<b>H17</b>	BT00.00-X-1000Z	<b>Technical modifications</b>	<b>9.12.98</b>
------------	-----------------	--------------------------------	----------------

***Rear axle center assembly dia. 168***

P35.31-0275-01

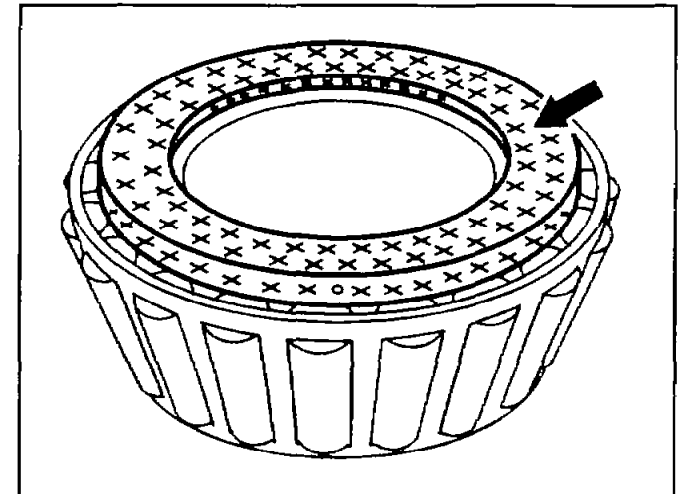
The thrust washer is permanently integrated on the small tapered roller bearing inner race of the drive pinion to facilitate assembly.

The thrust washer was clipped onto the tapered roller bearing inner race with 3 retaining lugs on the previous version.

P35.31-2014-11

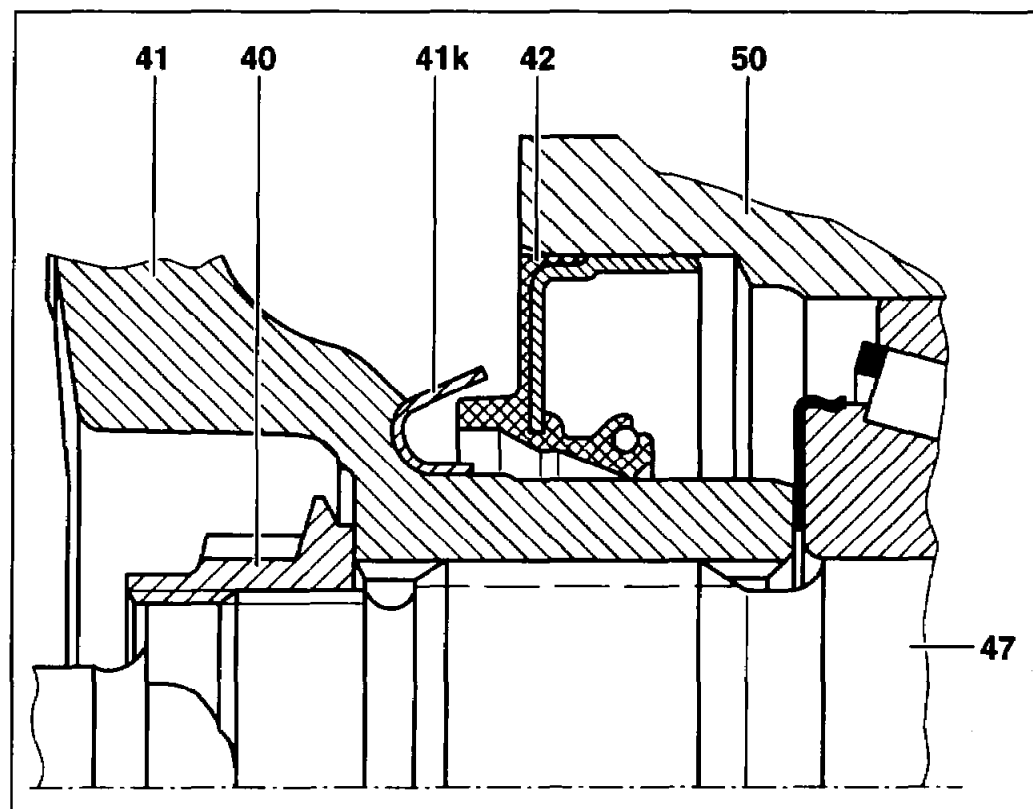
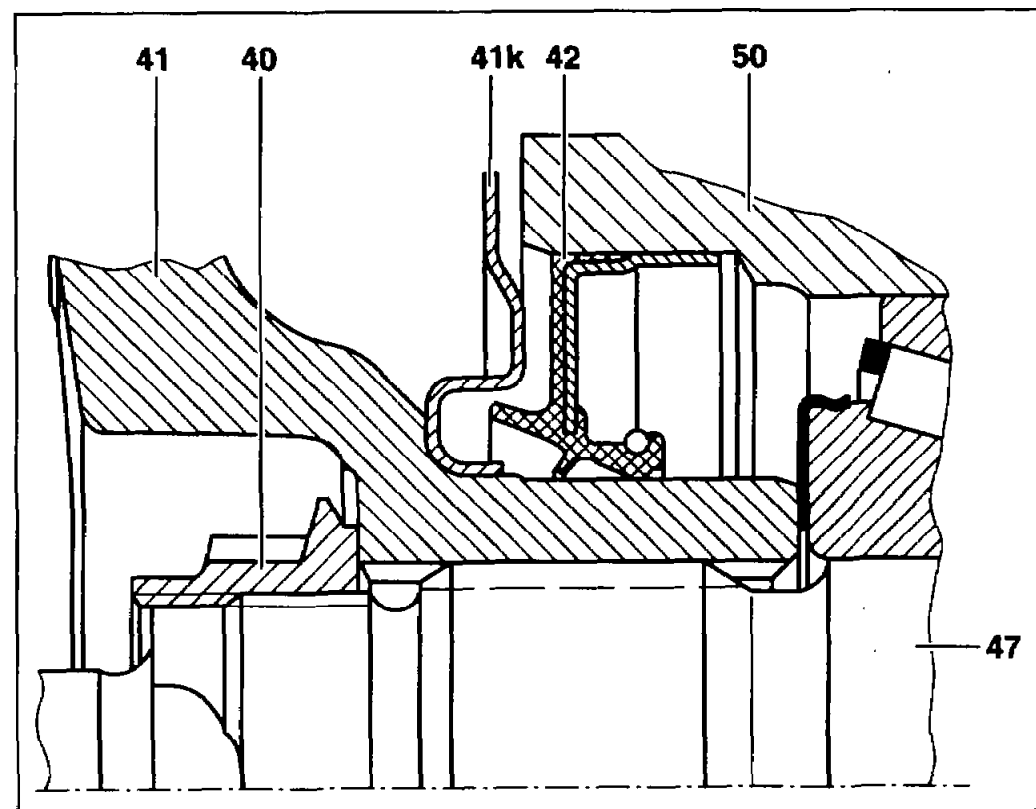
A new radial seal ring and new joint flange with protective ring has been fitted, phased in as of 01.04.98.

This improves the sealing on the drive pinion against dirt from outside.

When installing the **new joint flange**, it is essential to install the **new radial seal ring** as well. This is the only way to ensure correct sealing

When the new radial seal ring is installed, the previous joint flange can continue to be installed.

P35.31-0470-01

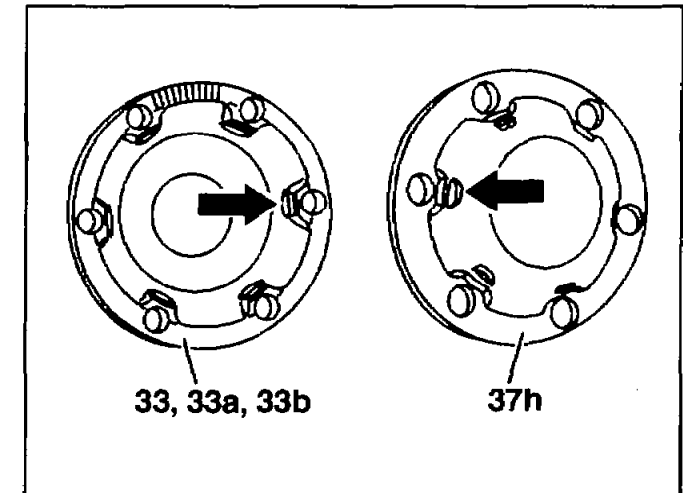
Connecting flange with centering.

The connection between the flange (33, 33a, 33b) and rear axle shaft has been made more accurate and the concentricity has been improved. The connecting flange (33, 33a, 33b) has turned surfaces and the end cover (37h) of the rear axle shaft has impressions (arrows).
